Re: Florida Power & Light Company
Proposed Turkey Point Units 6 and 7
Docket Nos. 52-040 and 52-041
Supplemental Response to Request for Additional Information Letter No. 004
Standard Review Plan Section 02.04.06 – Probable Maximum
Tsunami Flooding -Question No. 02.04.06-2 (eRAI 4809)

NRC RAI Letter No.: PTN-RAI-LTR-004

SRP Section: FSAR 02.04.06, Probable Maximum Tsunami Hazards

NRC RAI Number: 02.04.06-2 (eRAI 4809)

**Figure 2.4.6-210 Extent of Selected Tsunami Model Domain and Subdomains
SITE, ISLANDS, and DEEP**

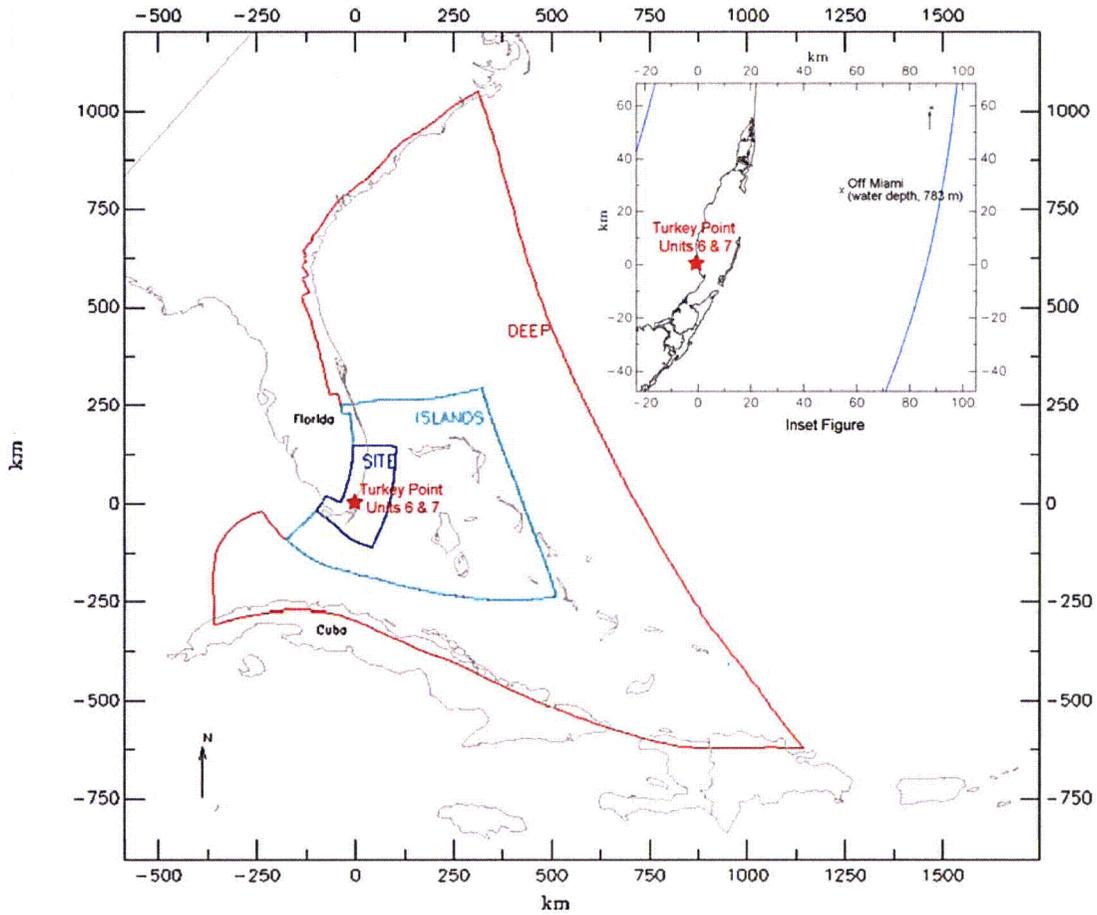
Section C.I.2.4.6.4 of Regulatory Guide 1.206 (RG 1.206) provides specific guidance with respect to tsunami analysis. This includes providing a complete description of the analysis procedure used to calculate tsunami wave height and period at the site, including the theoretical bases of the models, their verification and the conservatism of all input parameters.

Provide a complete description in the updated FSAR of the numerical modeling methodology used for the revised tsunami analysis and supply water level results specific to the site, taking into account the regional and local (site-specific) bathymetry/topography.

The selected model domain is shown on Figure 2.4.6-210. The east model boundary in deep waters generally follows the simulated propagation of tsunami wave front after 6.5 hours of travel in Mader's analysis (Reference 209). The 6.5 hour wave front is selected to maximize the coverage of the ocean in the model and also allow the model to be defined by one open sea boundary with a uniform boundary condition. This open boundary extends from Havelock, North Carolina to north east of the Dominican Republic. The north and west model boundaries follow mostly the coastlines of the southeastern United States. The south model boundary is set along the northern coastlines of the Dominican Republic, Haiti, and Cuba. The small passage between Haiti and Cuba is conservatively assumed to be blocked. Southwest of the site, the model includes a portion of the Straits of Florida, the area protruding past the Florida Keys, to allow the tsunami wave to travel farther into the Gulf of Mexico so that the effect of this boundary on the site is minimized. Extending the model farther into the Gulf of Mexico is not necessary, as the maximum tsunami water level at the site would occur before the effect of this boundary is reflected back at the site. Consequently, the model boundary in the Gulf of Mexico is simulated as a closed boundary.

A nested grid system with three different grid resolutions is developed using the domain decomposition tool within RGFRID to appropriately resolve tsunami wave modification near the site. The three grid subdomains are shown on Figure 2.4.6-210. The first
